# 802.3dj D1.0

## Comment Resolution - Electrical track

Adee Ran, Cisco

**Figure 176E-2—Components of a 200 Gb/s per lane AUI-C2M interface and insertion loss budget at 53.125 GHz**

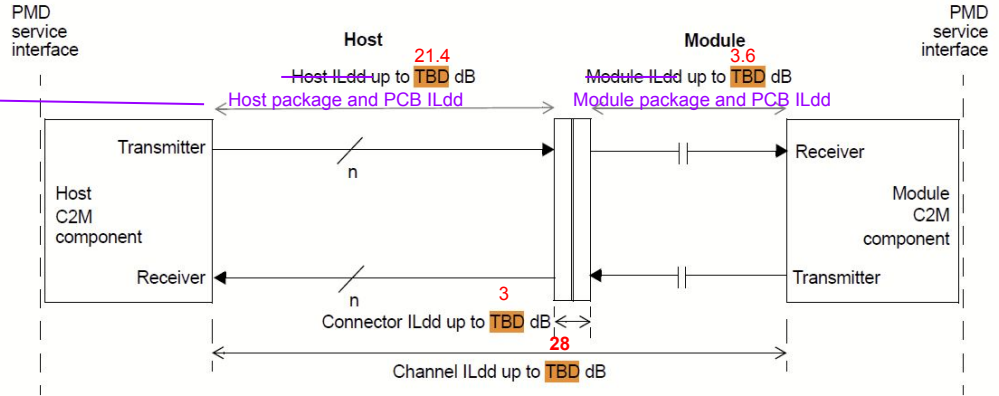
CI 176E SC 176E.4.1 P632 L6 # 73

The IL\_dd for AUI C2M channel is a TBD

The referenced presentation is [https://www.ieee802.org/3/dj/public/24\\_01/lusted\\_3dj\\_03\\_2401.pdf](https://www.ieee802.org/3/dj/public/24_01/lusted_3dj_03_2401.pdf). The comment is against 176E.4.1 (Recommended channel characteristics/Insertion loss), which has an equation for the ILdd limit. The suggested remedy does not address the equation. The proposed value for this TBD (Channel ILdd) is **33 dB**. Comment #134 suggests **28 dB** for the same TBD.
